[Docket No. 99-SW-08-AD; Amendment 39-11657; AD 2000-07-03]

Airworthiness Directives; Robinson Helicopter Company Model R44 Helicopters

ACTION: Final rule.

**FIGURE 1**

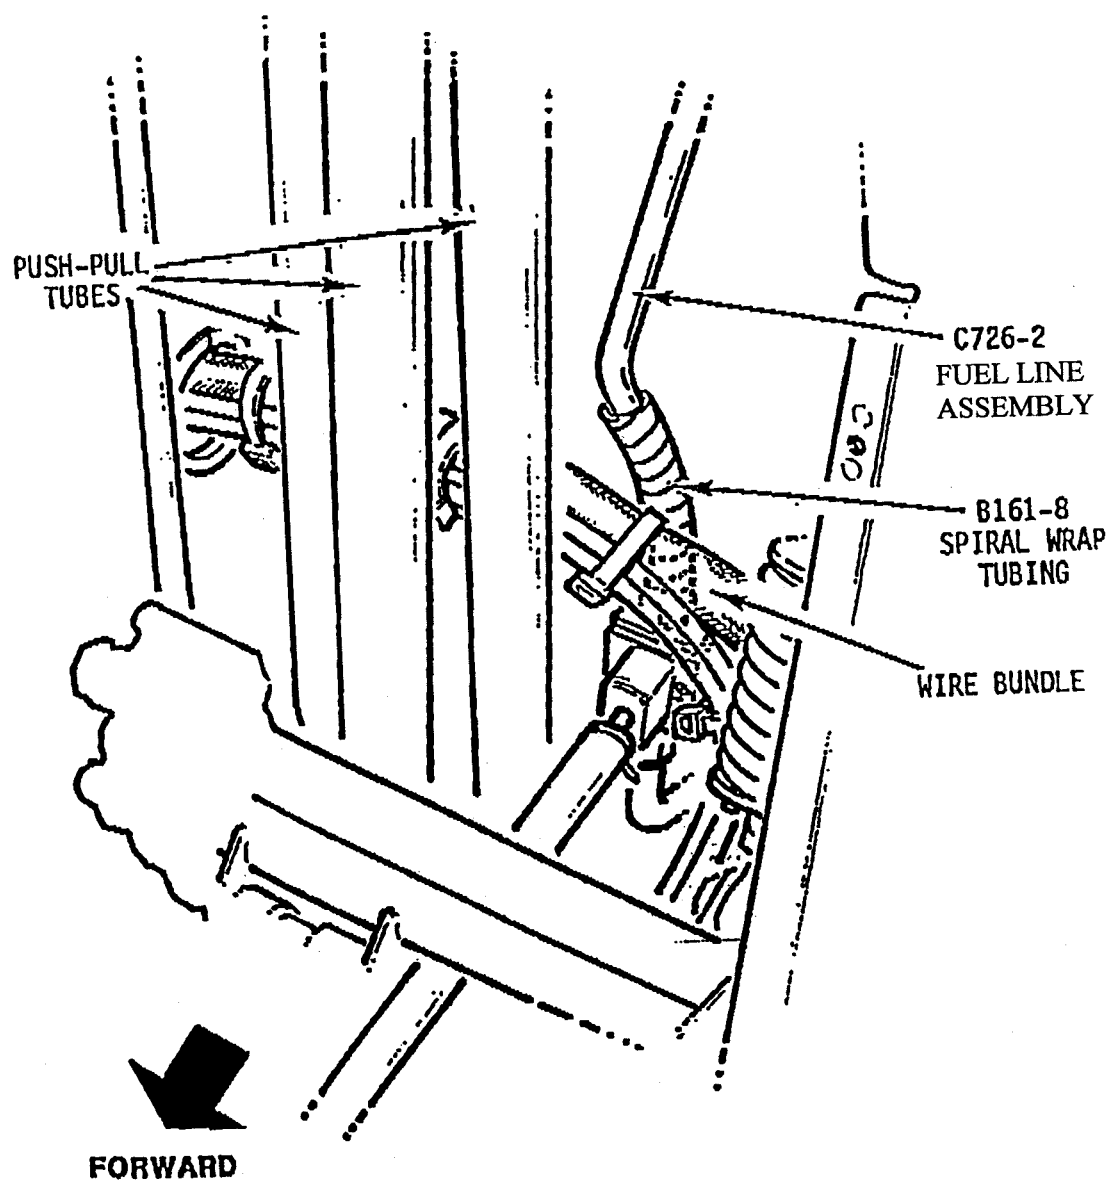
(d) Install a 3-inch section of spiral wrap tubing, P/N B161-8, on the fuel line assembly as shown in Figure 1. Push the spiral wrap tubing down until it is against the fuel line fitting.
